MINERALS PROGRAM INSPECTION REPORT
PHONE: (303) 866-3567

MINE NAME: Horton Gravel Pit	MINE/PROSPECTING ID#: M-1985-135	MINERAL: Sand and gravel	COUNTY: Larimer
INSPECTION TYPE: Monitoring	INSPECTOR(S): Amy Eschberger, Rob Zuber	INSP. DATE: February 13, 2020	INSP. TIME: 12:30
OPERATOR: Larimer County	OPERATOR REPRESENTATIVE: Justin Hersh	TYPE OF OPERATION: 112c - Construction Regular Operation

M-1985-135 / Horton Gravel Pit / Larimer County

LARIMER COUNTY ENGINEERING			
EXHIBIT "D" MINING PLAN	DESIGN		
	DRAWN K. LOFTEN		
	CHECKED		
APPROVED	DATE	SHEET	OF

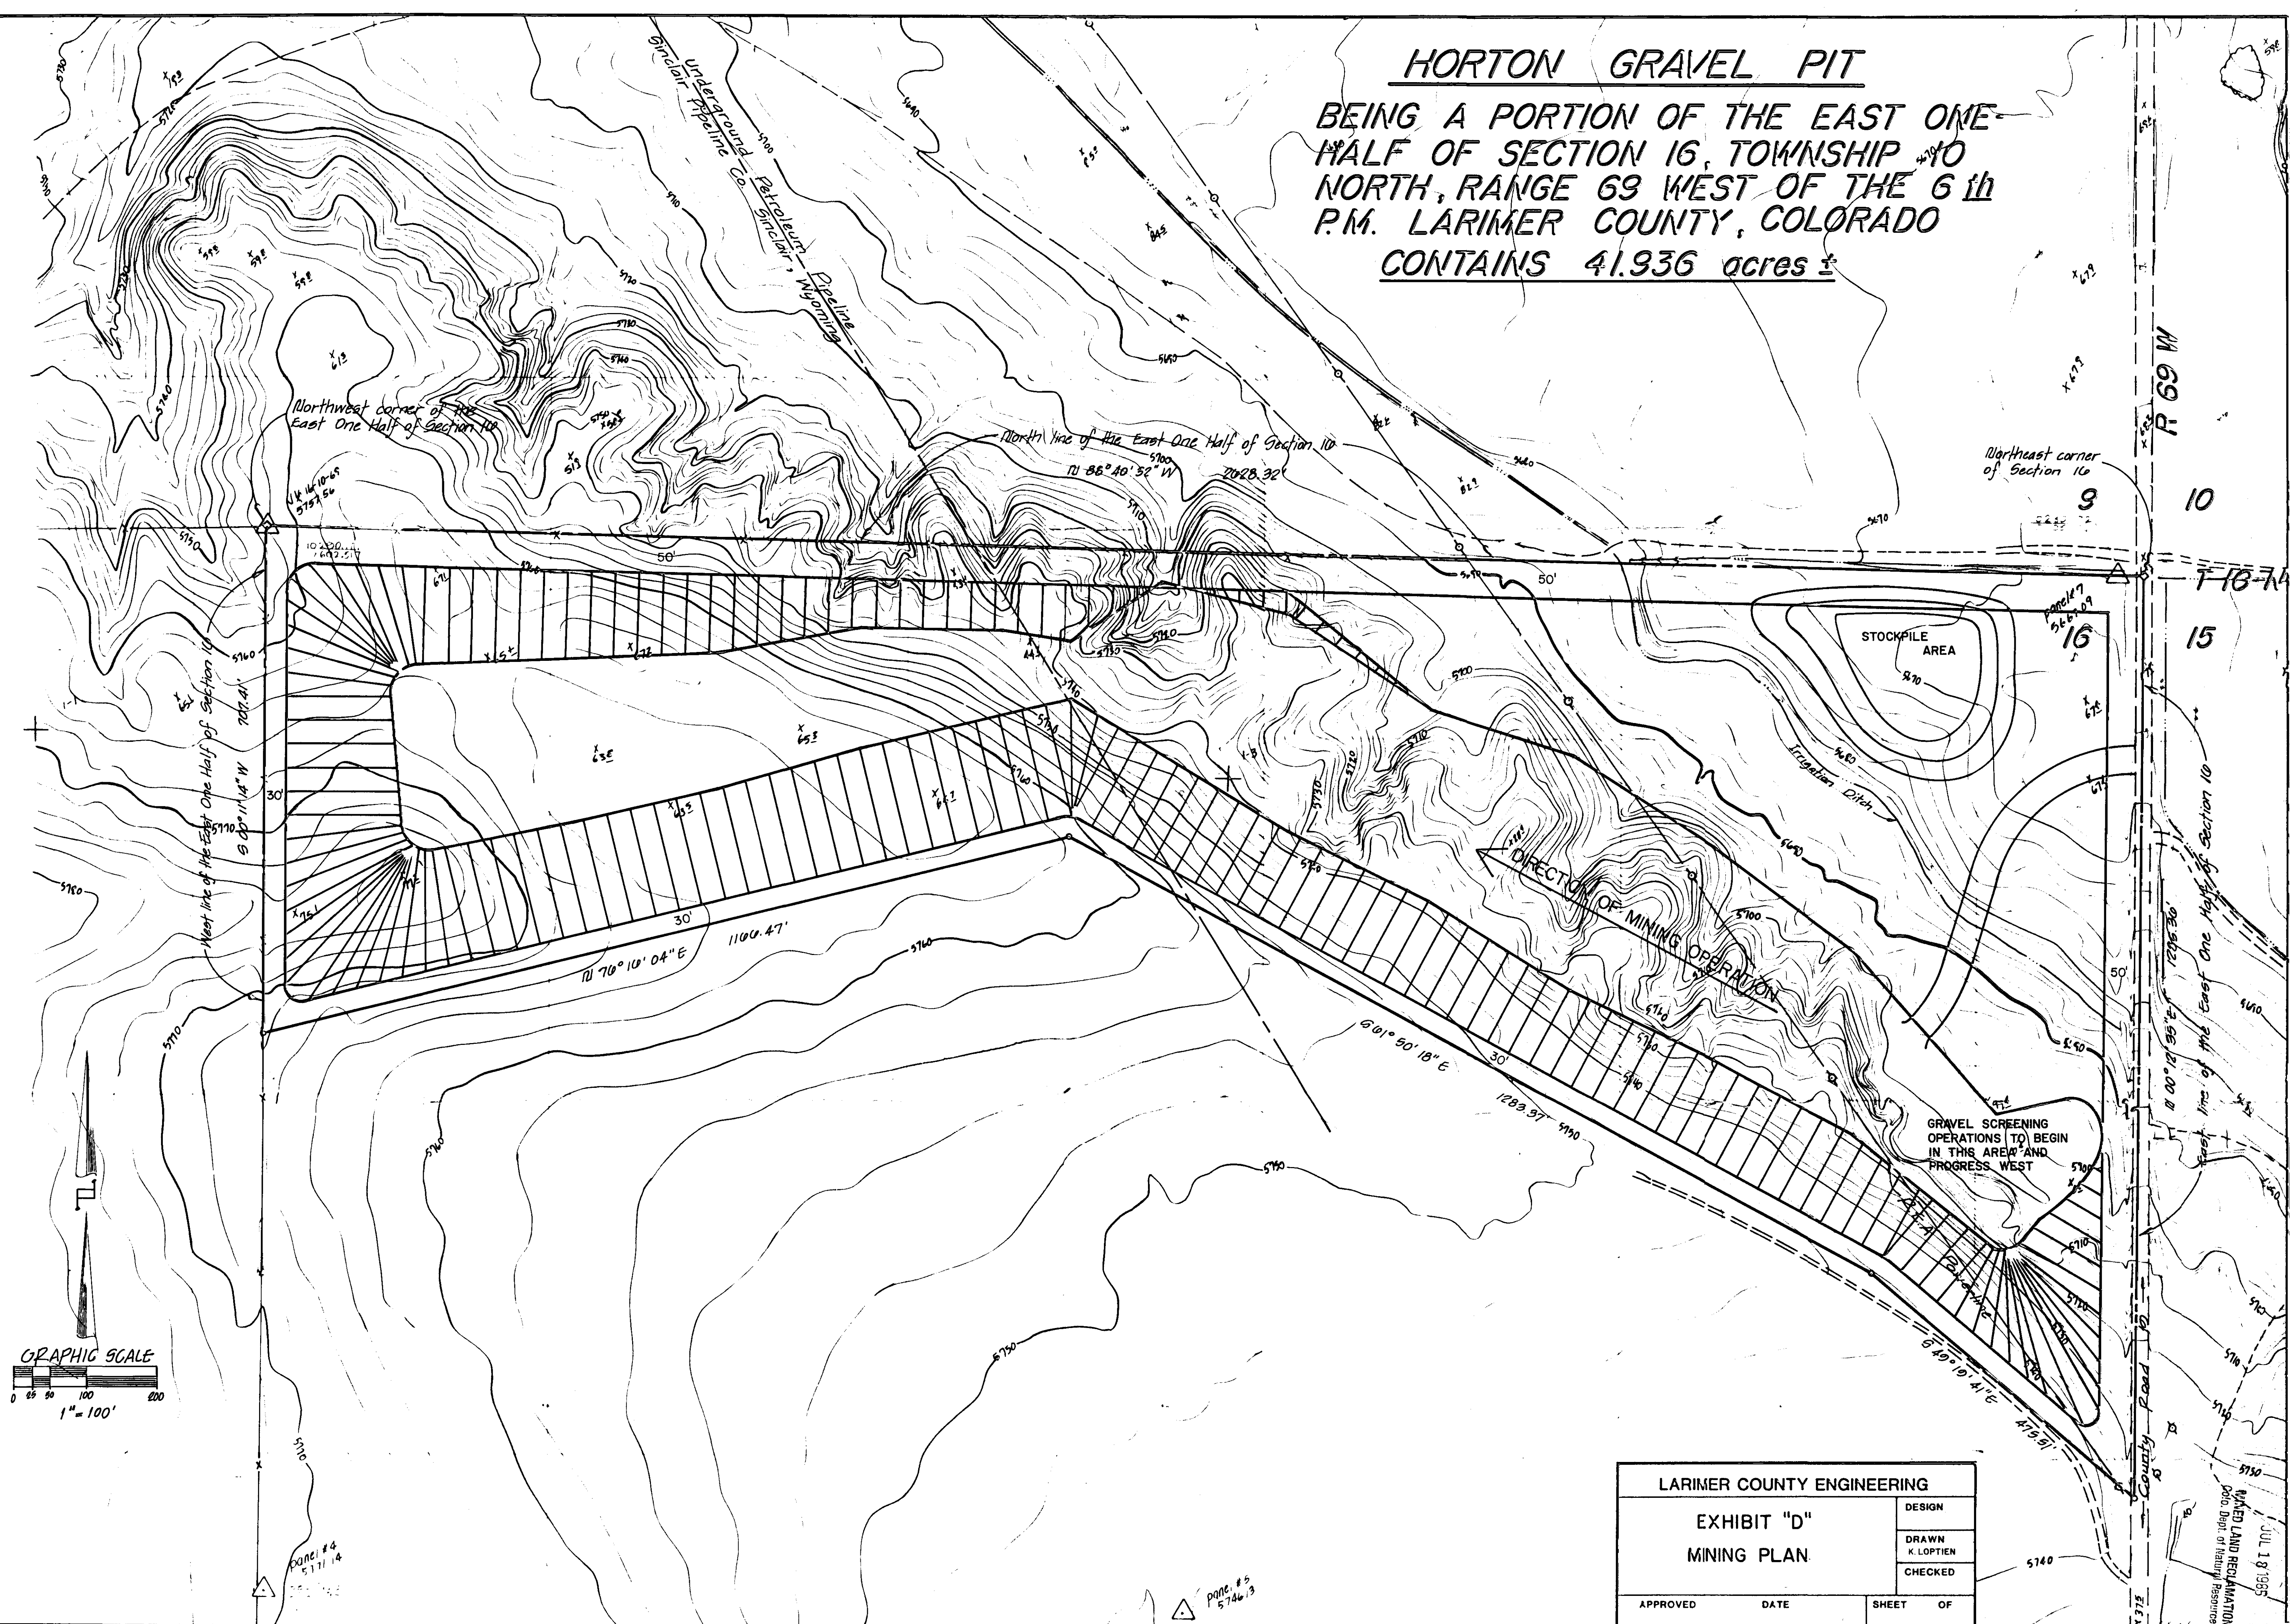
PROBLEM: The current mining plan and mining plan map need to be updated pursuant to Rules 6.4.3 and 6.4.4. The operator must provide sufficient information to describe or identify how the operator intends to conduct the operation. Specifically, the operator has installed stormwater management structures (riprap channels, buried culvert), a new access road, and a county staging area, which are not included in the approved mining plan or portrayed on the approved mining plan map.

The stormwater management structures installed at the site are not included in the approved mining plan or portrayed on the approved mining plan map (see enclosed mining plan map). Therefore, a problem is cited in this report (see pages 1 and 2) pursuant to Rules 6.4.3 and 6.4.4, requiring the operator to submit a Technical Revision (see enclosed form) to update the mining plan and mining plan map to address the stormwater management structures installed at the site. These structures are also not included in the approved reclamation plan or portrayed on the approved reclamation plan map (see enclosed reclamation plan map). Therefore, a separate problem is cited in this report (see page 2) pursuant to Rules 6.4.5 and 6.4.6, requiring the operator to submit, in the same Technical Revision, an updated reclamation plan and reclamation plan map that address the stormwater management structures installed at the site.

CORRECTIVE ACTIONS: By the corrective action date, the operator shall submit a Technical Revision, with the required \$216 fee, to update the current approved mining plan and mining plan map to reflect existing and proposed activities at the site, particularly to address the stormwater management structures, new access road, and county staging area constructed at the site.

- 1) Submit photographic evidence an appropriate mine identification sign has been posted at the main site entrance.
- 2) Submit a Technical Revision to update the approved mining and reclamation plans and maps to include the following:
 - a. Describe the stormwater management structures installed at the site (in the updated mining plan), portray these structures on the updated mining plan map, and if these structures will remain for reclamation, portray them on the updated reclamation plan map. If any of these structures will be reclaimed or modified for reclamation, describe how they will be reclaimed/modified in the updated reclamation plan.
 - b. Describe the new site access and haul road constructed at southern edge of site (in the updated

mining plan), portray these features on the updated mining plan map, and if these features will remain for reclamation, portray them on the updated reclamation plan map. If these features will be reclaimed, describe how they will be reclaimed in the updated reclamation plan.

- c. Describe the county staging area constructed at the site (in the updated mining plan), portray this area on the updated mining plan map, and if this feature will continue to be used by the county after reclamation, portray this feature on the updated reclamation plan map. If this feature will be reclaimed, describe how it will be reclaimed in the updated reclamation plan.

LARIMER COUNTY ENGINEERING	
EXHIBIT "F"	
RECLAMATION PLAN	
DESIGN	DRAWN
CHECKED	DATE
APPROVED	SHEET OF

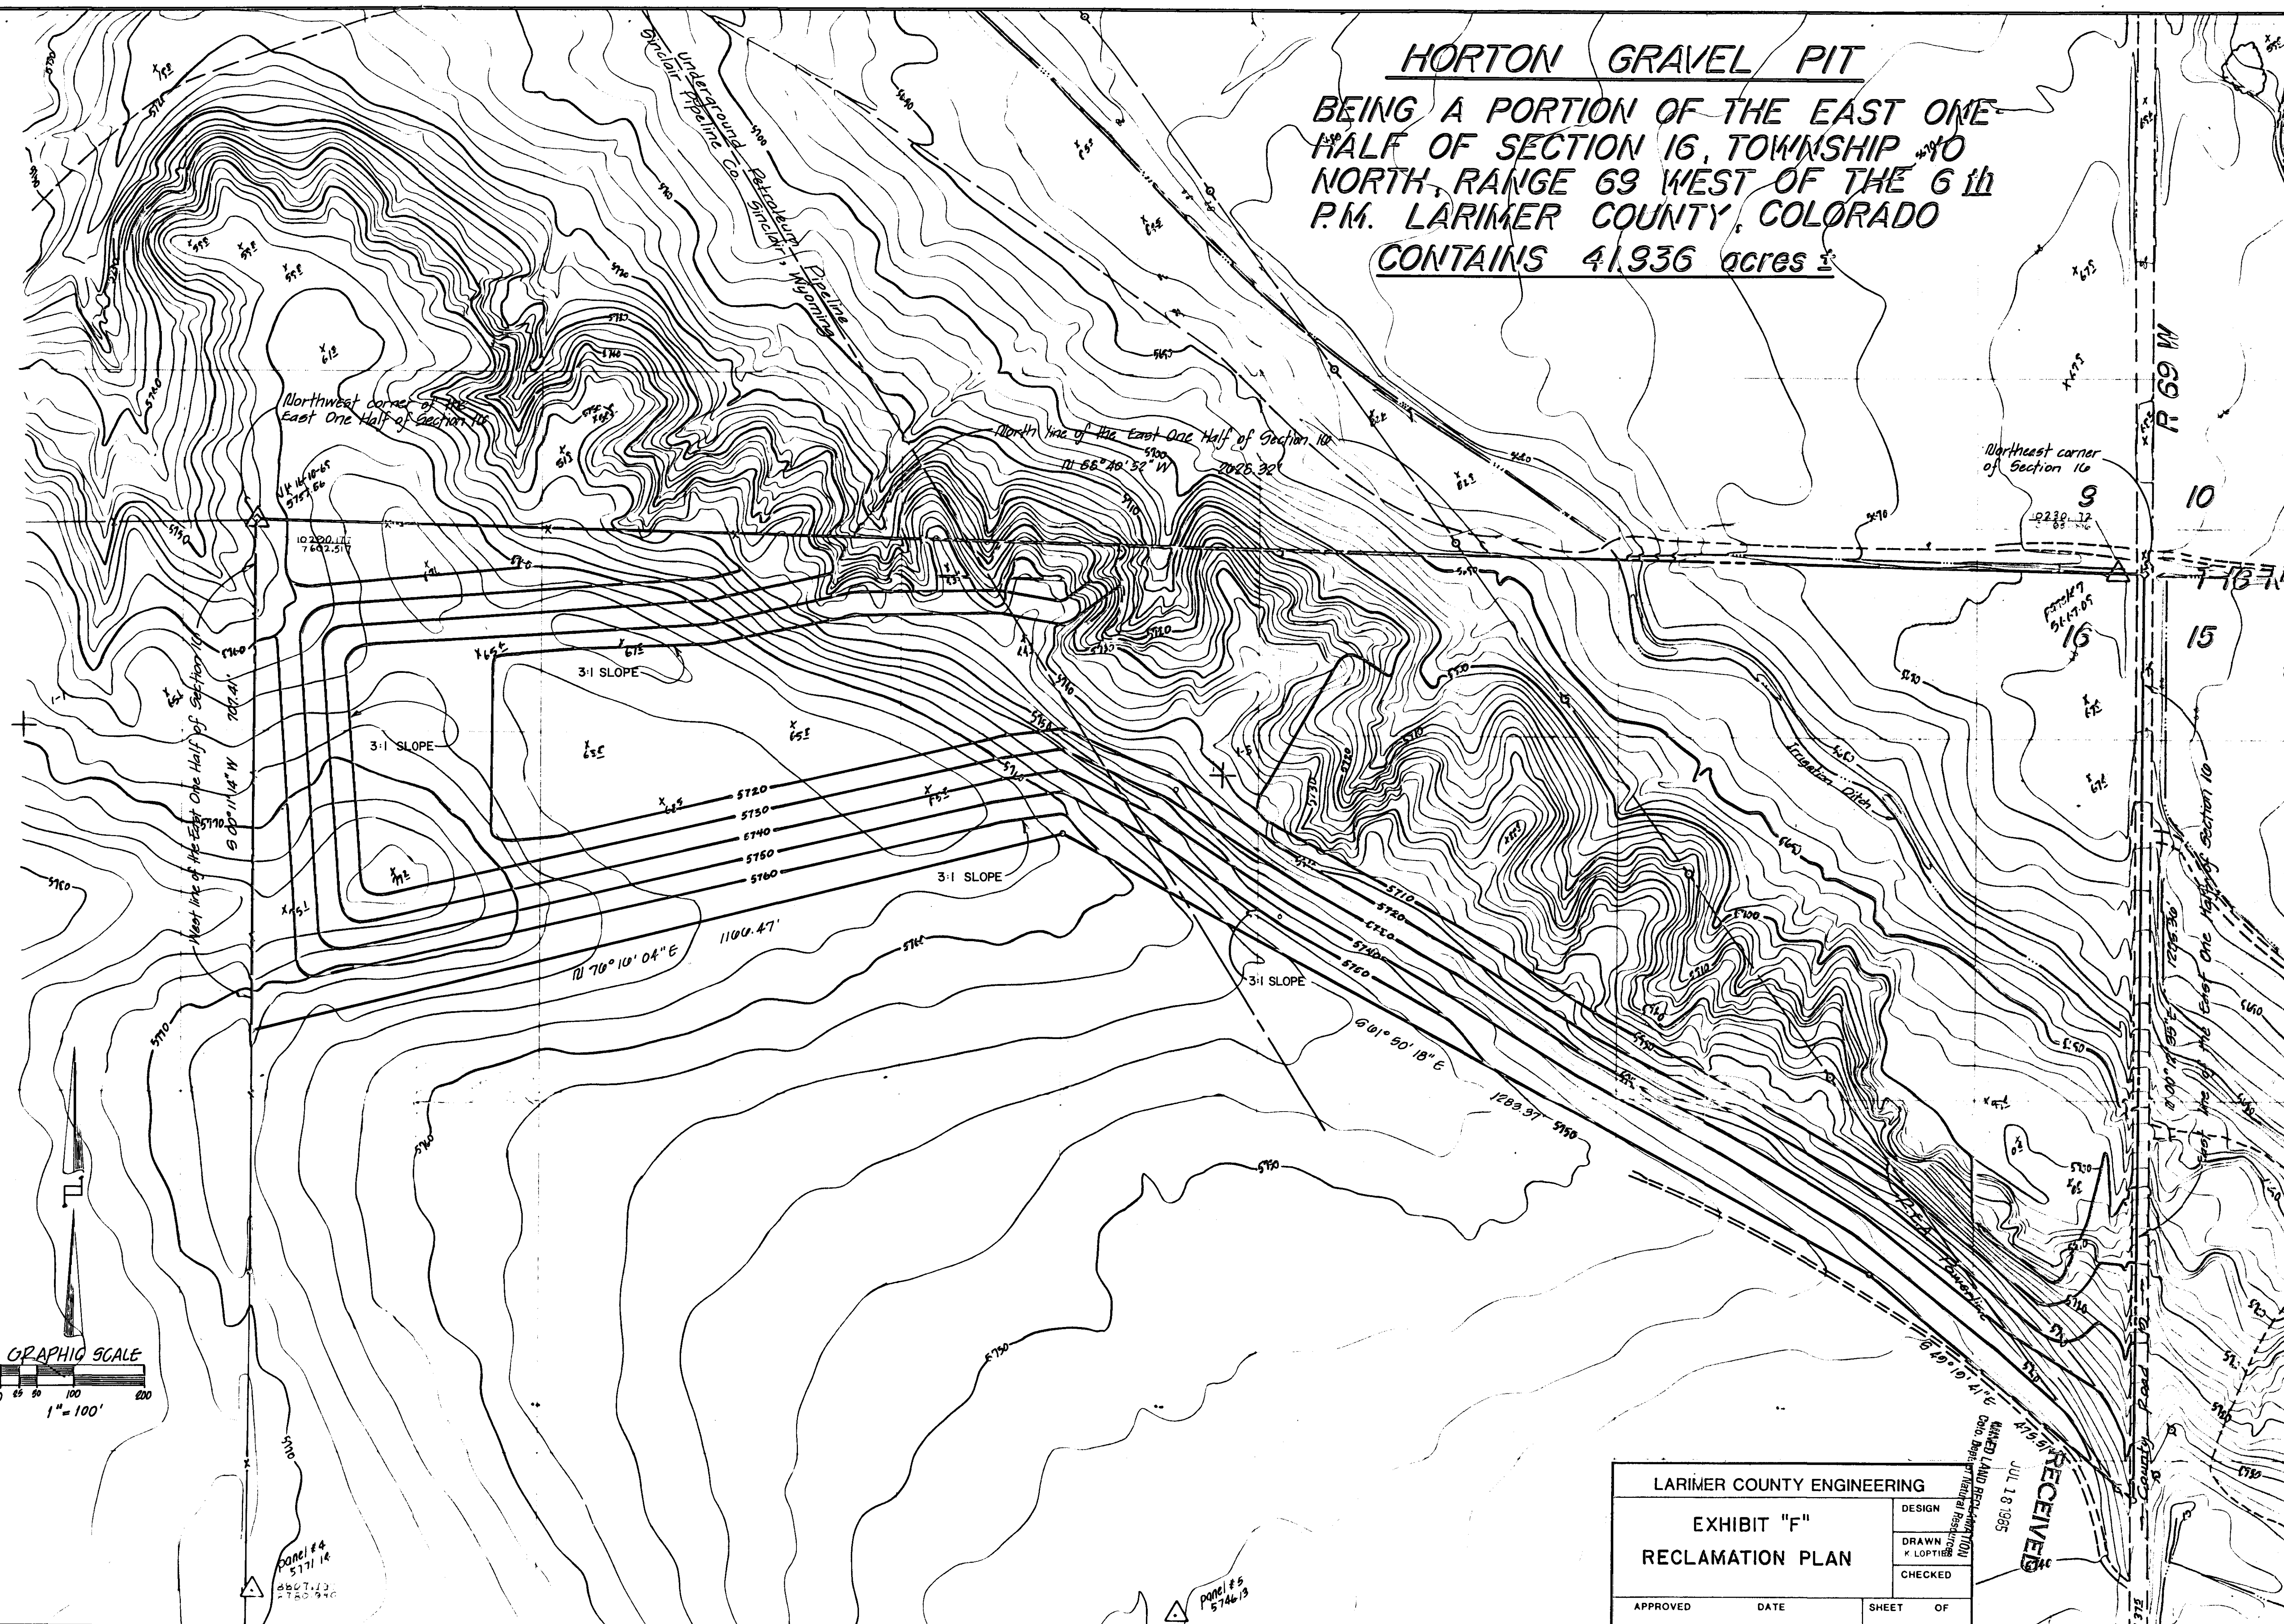
PROBLEM: The current reclamation plan and reclamation plan map need to be updated pursuant to Rules 6.4.5 and 6.4.6. The operator must describe how reclamation will be achieved on all affected land. Specifically, the operator has installed stormwater management structures (riprap lined channels, buried culvert), a new access road, and a county staging area, which are not included in the approved reclamation plan or portrayed on the approved reclamation plan map.

CORRECTIVE ACTIONS: By the corrective action date, the operator shall submit a Technical Revision, with the required \$216 fee (can be same revision submitted for problem cited above), to update the current approved reclamation plan and reclamation plan map to reflect existing and proposed activities at the site, particularly to address the stormwater management structures, new access road, and county staging area constructed at the site. Any of these features proposed to remain for reclamation shall be portrayed on the updated reclamation plan map.
